## KNOXVILLE HISTORIC ZONING COMMISSION STAFF REPORT - CERTIFICATE OF APPROPRIATENESS APPLICATION

PROPERTY ADDRESS: 1206 Luttrell St 37917 FILE NO.: 1-B-14-HZ

**MEETING DATE:** 2/20/2014

1206 Luttrell – Older phorograph

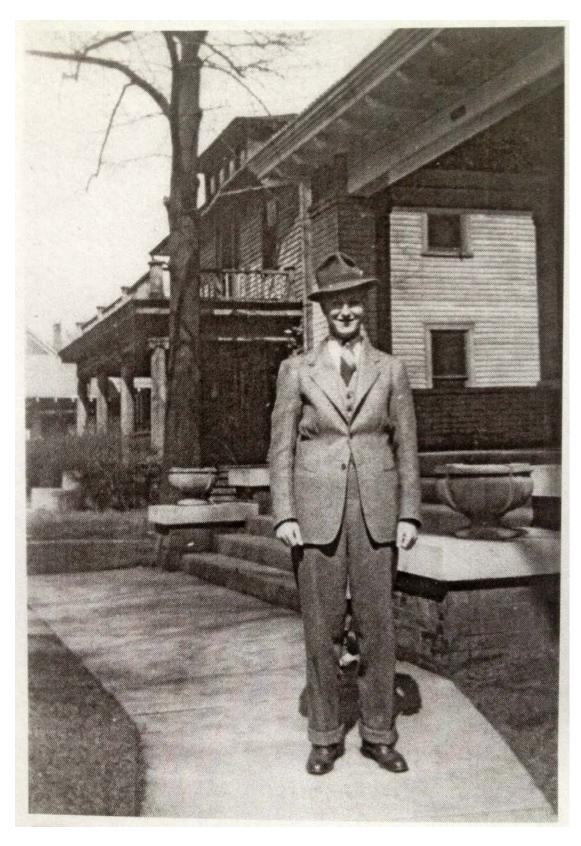
- 2) Documentation on the original appearance of the house in the 1920s or 1930s has been submitted to indicate the design of the front porch and a portion of the front façade. One-over-one windows are shown and a central door on the 2nd level leading to a balustraded porch roof. The columnssupporting a full-façade are square with lonic volutes. The photos does not show a balustrade on the historic porch does not

Approval of two square wood replacement columns to match those at 1101 Luttrell Street or with Ionic volutes. Construct new brick steps if mock-up shows that the brick will match that existing on the foundation; otherwise the steps are to be of concrete. Construct fixed multi-light french door panel in center 2nd level. Install 2x2 square balustrade and handrail with molded top rail to meet building code.
